# RFI 437

## Girder 4, FS 17

RFI 437 - FS 17, G4

For	Cleveland InnerBelt : Field Splice - Node 7153	Made	SAE	8/5/2011	Job Number	49633	Revised	DJG	Date	10/11/2011
		Checked	WME	8/5/2011	Sheet No.		Checked	SJL	Date	10/11/2012
		Backchk'd	SAE	8/5/2011		Backchk'd	DJG	Date	10/11/2011

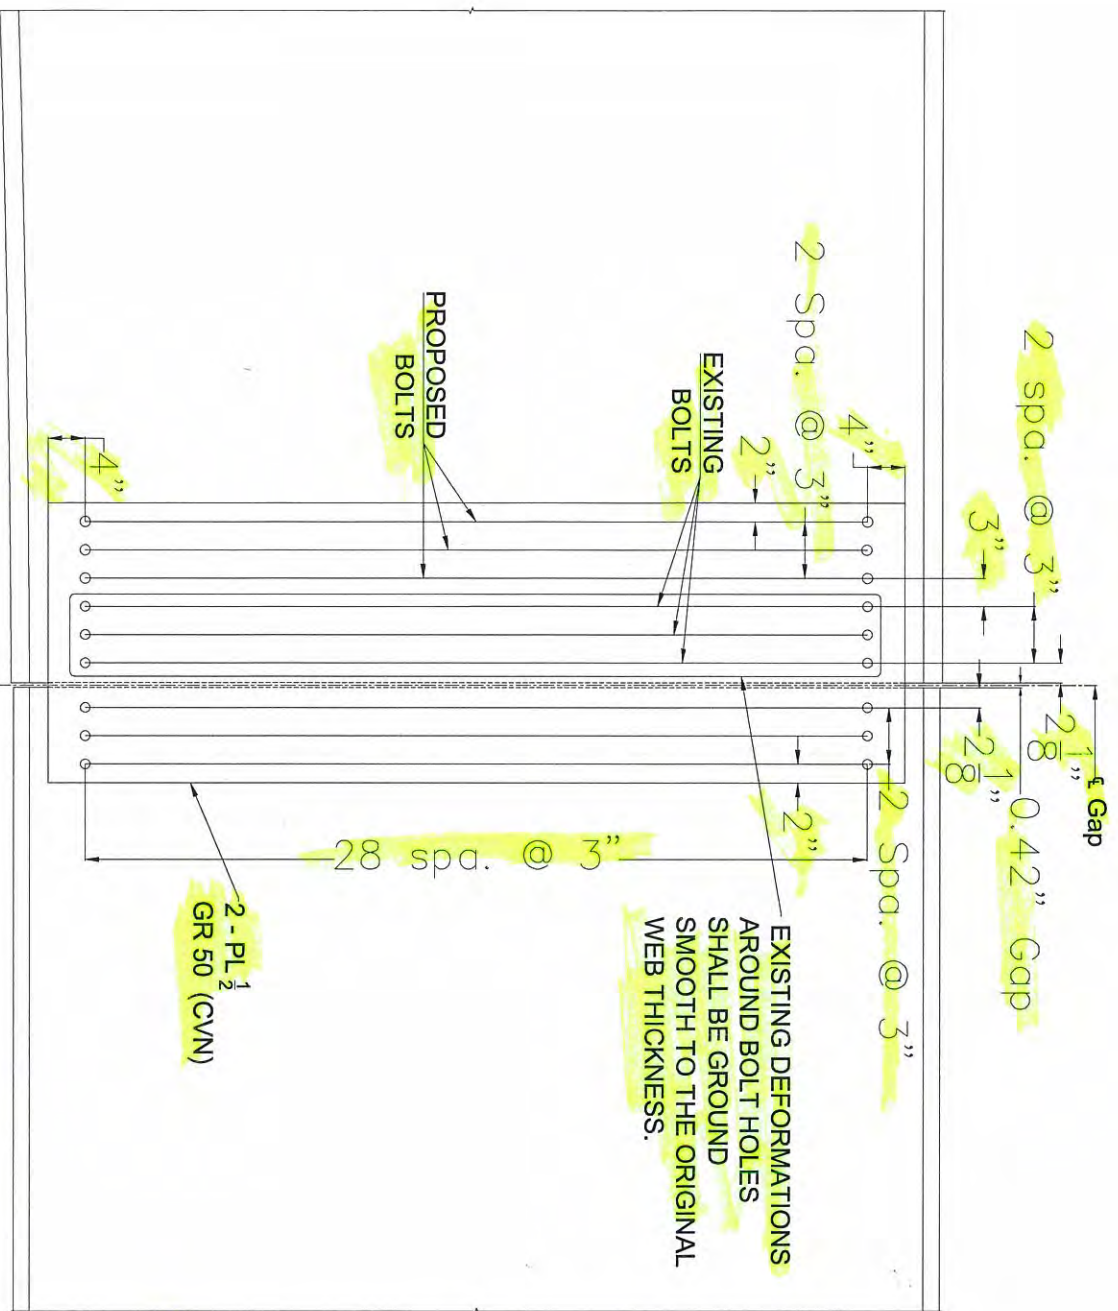
→ FS 17, G4 had several holes that incurred damage in the web during fit-up in the field.

→ New columns of bolts are proposed to remedy the damaged web splice.

EXISTING DEFORMATIONS AROUND BOLT HOLES SHALL BE GROUND SMOOTH TO THE ORIGINAL WEB THICKNESS.

2 - PL 1/2 GR 50 (CVN)

1. FLANGE SPLICE NOT SHOWN FOR CLARITY.
2. ALL MATERIAL AND WORKMANSHIP SHALL BE IN ACCORDANCE WITH THE RFC PLANS.
3. ALL BOLTS SHALL BE 1" DIAMETER.
4. ALL EXISTING HOLES SHALL BE DYE PENETRANT INSPECTED IN ACCORDANCE WITH ASTM E165, TYPE 1 FLUORESCENT PENETRANT TESTING, METHOD C. THE INSIDE SURFACE OF THE HOLE SHALL BE INSPECTED. PRIOR TO INSPECTION, THE INSIDE SURFACE OF THE HOLE SHALL BE CLEANED OF ALL DIRT, GREASE AND OTHER SUBSTANCES IN ACCORDANCE WITH ASTM E165, A1.
5. PROPOSED BOLT HOLES IN WEB SHALL BE FIELD DRILLED 1 1/16" DIAMETER.

# Proposed Web Splice Design Scenario 1

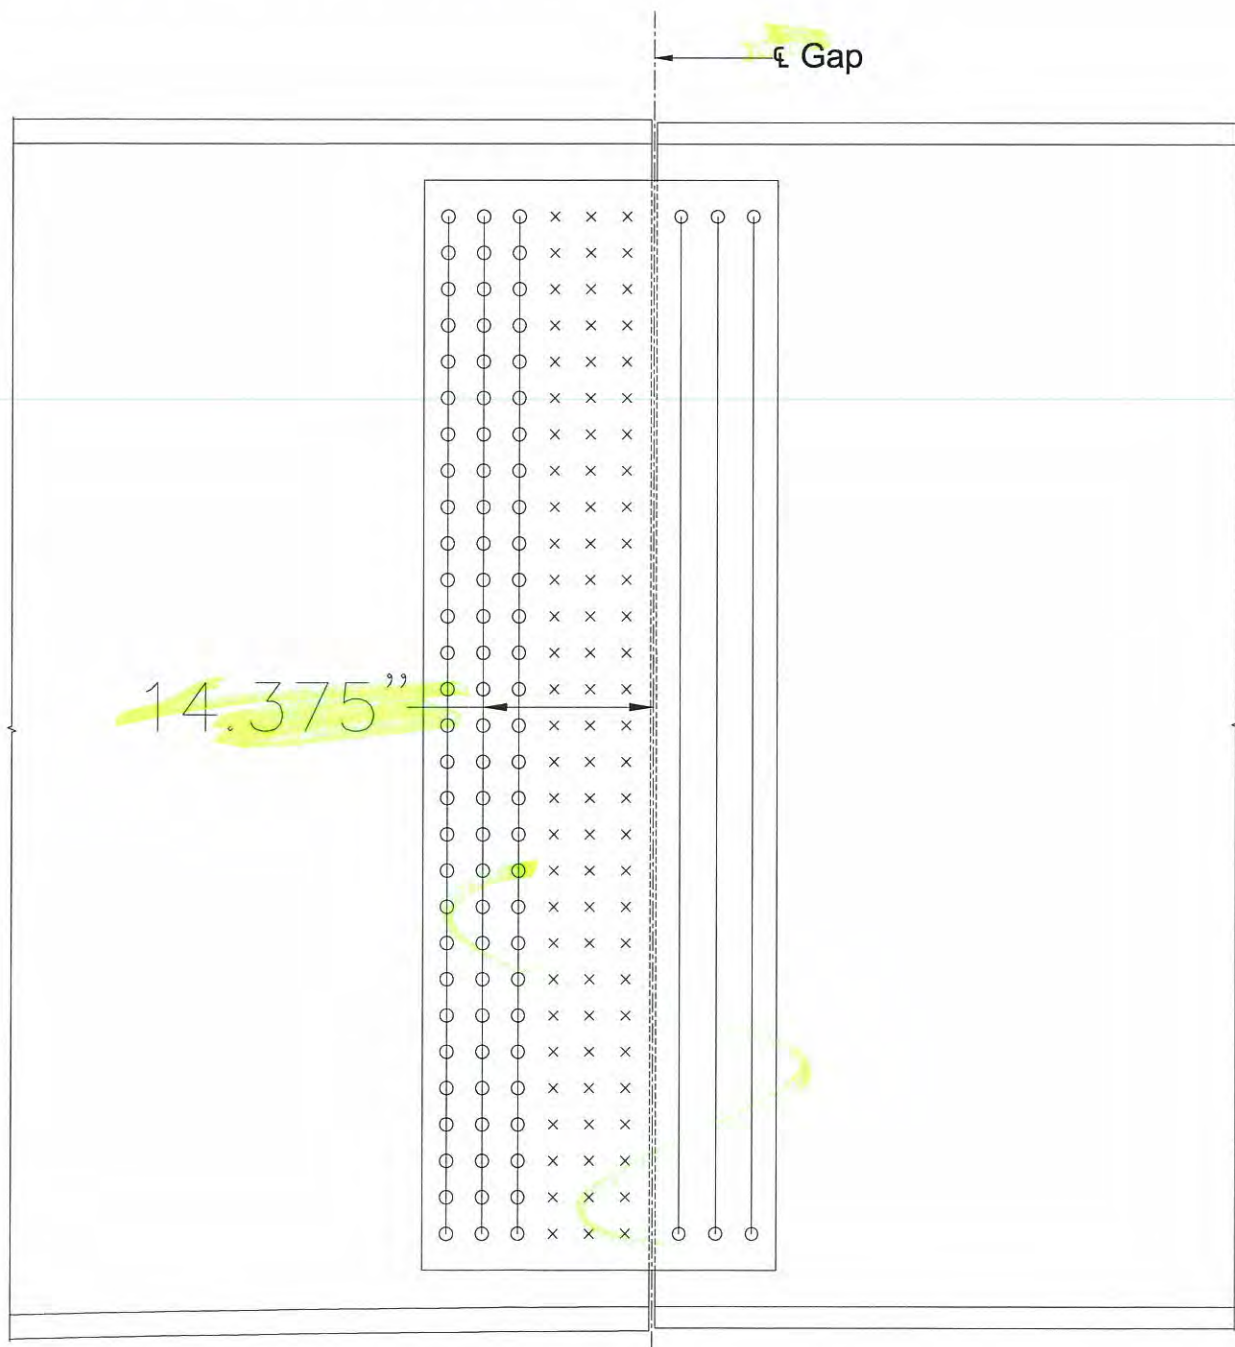
① Left side (damaged side) of the splice not considering any of the damaged holes.  
 $e = \text{¢ of gap to ¢ of new holes.}$

$$\textcircled{1} e_1 = 2\frac{1}{8} + \frac{0.5}{2} + (2)(3") + 3" + 3"$$

$$e_1 = 14.375"$$

## Design Scenario 2

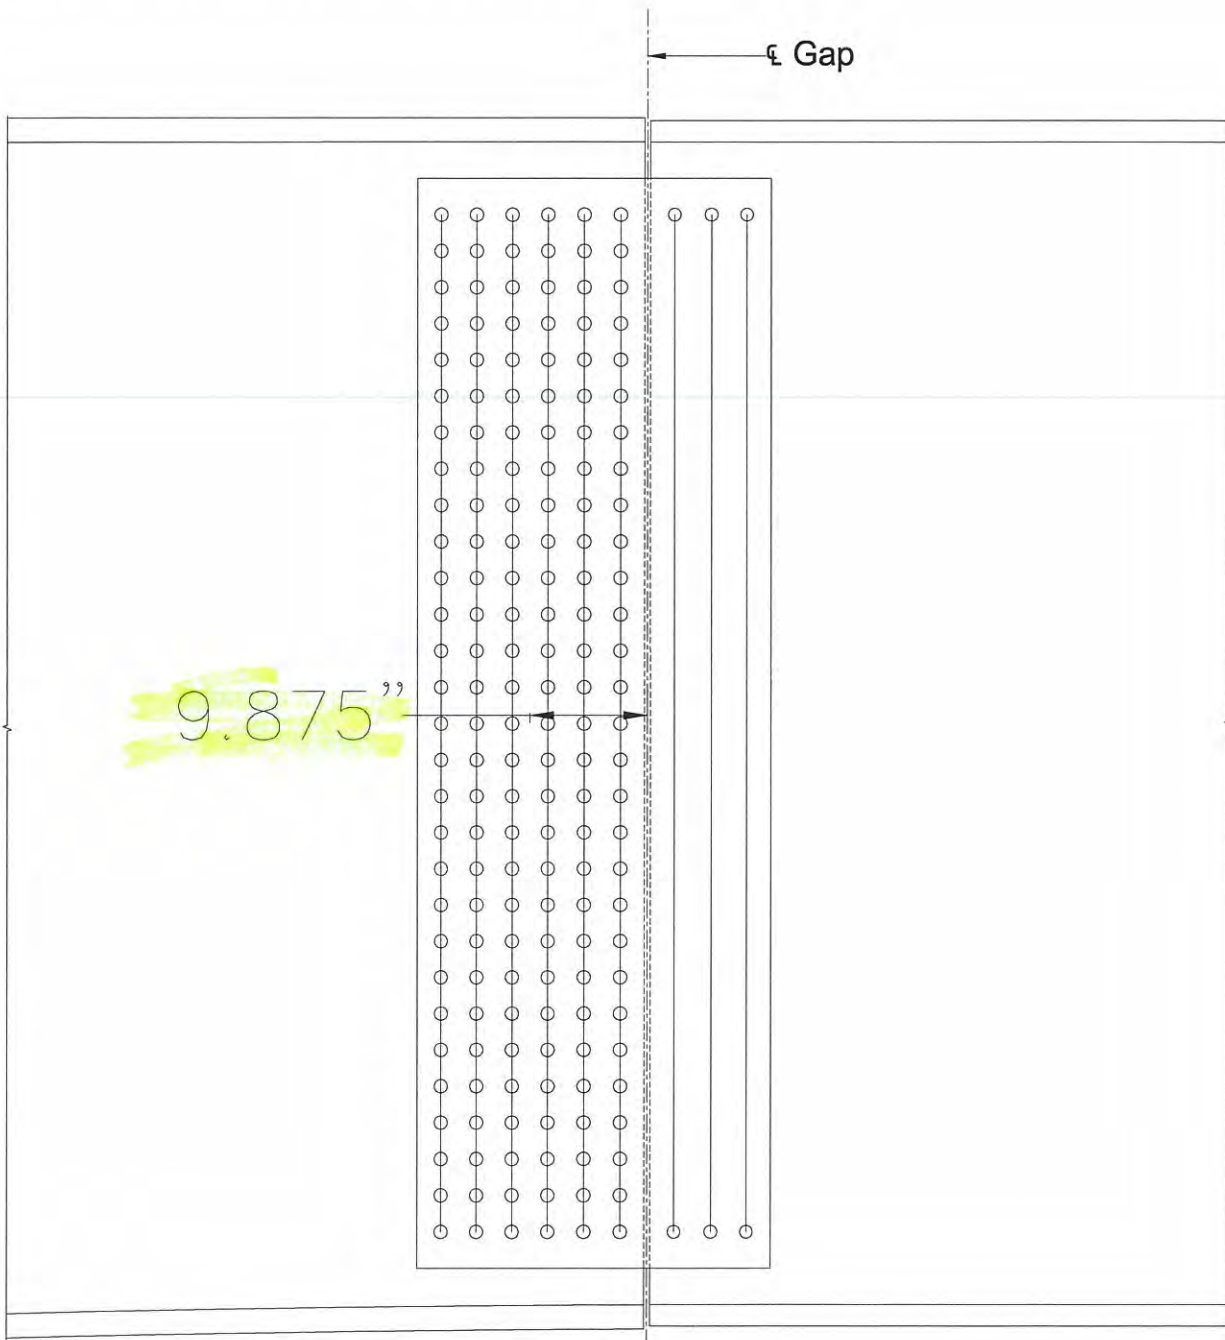
② Left side (damaged side) of the splice considering all holes, both new and existing.  
 $e = \text{¢ of gap to ¢ of all holes on left side.}$

$$\textcircled{2} e_2 = 2\frac{1}{8} + \frac{0.5}{2} + (5)(3") / 2$$

$$e_2 = 9.875"$$

## Design Scenario 3

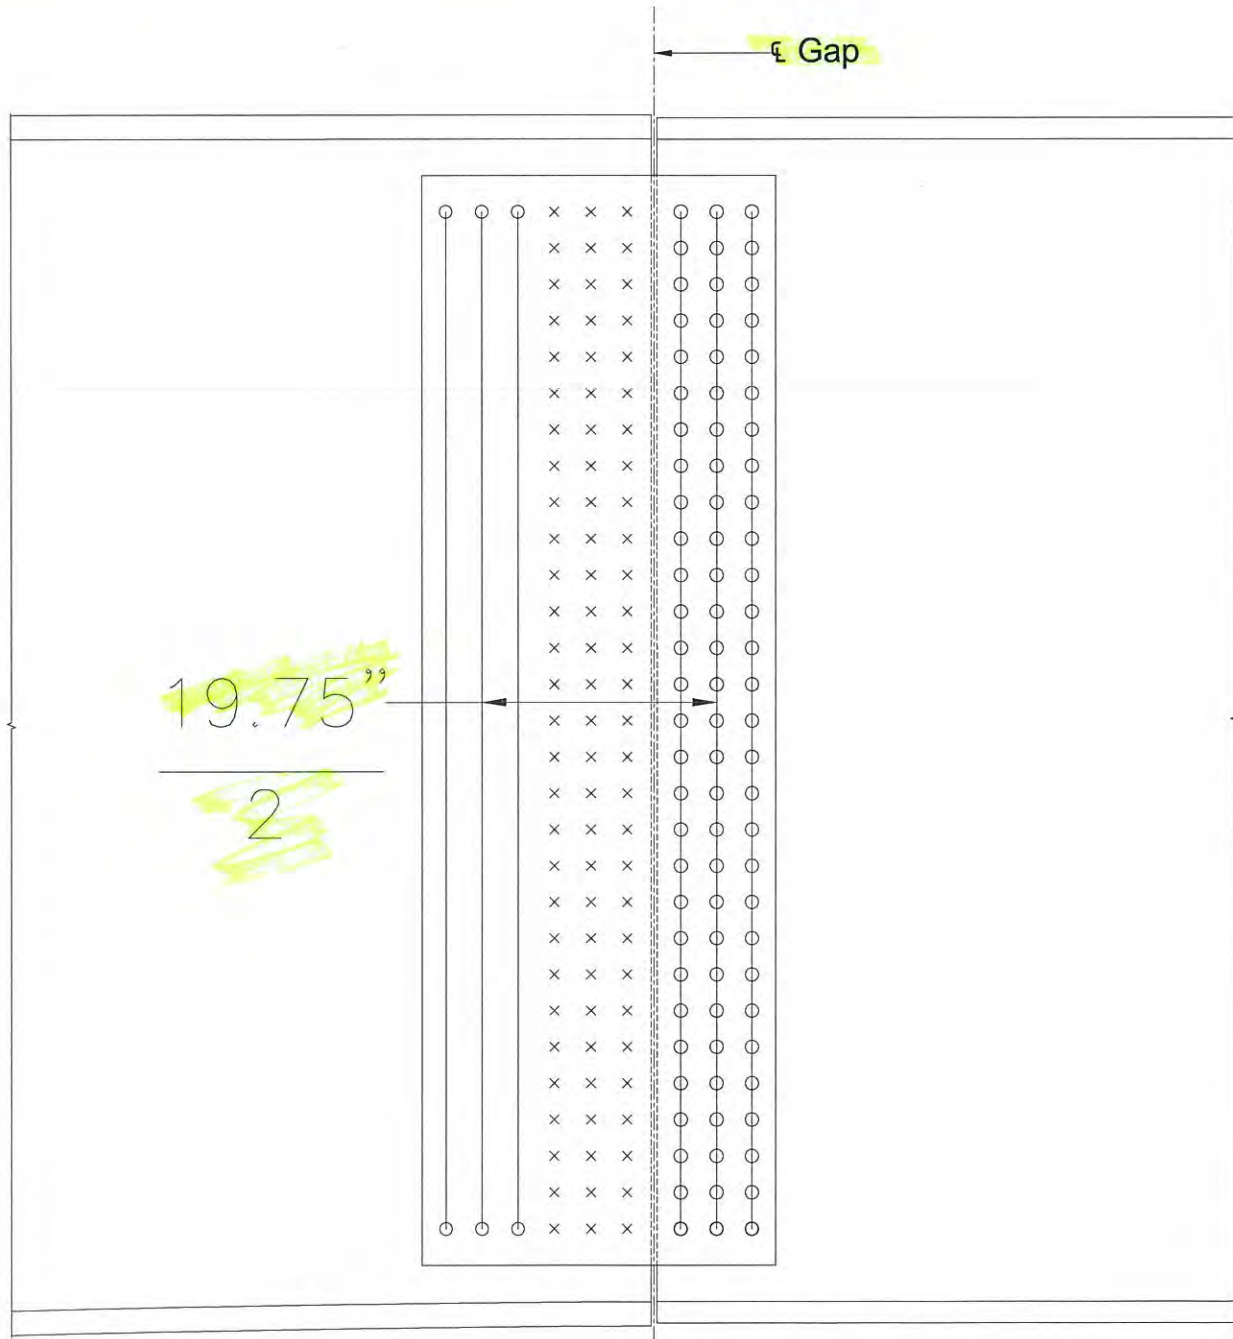
③ Right side of the splice with existing, undamaged holes.  
 $e = (\text{¢ of right side holes to the ¢ of left side proposed, undamaged holes}) / 2$

$$\textcircled{3} e_3 = \frac{[(4)(3") + 2\frac{1}{8} + 2\frac{1}{8} + \frac{1}{2} + 3"]}{2}$$

$$e_3 = 9.875"$$
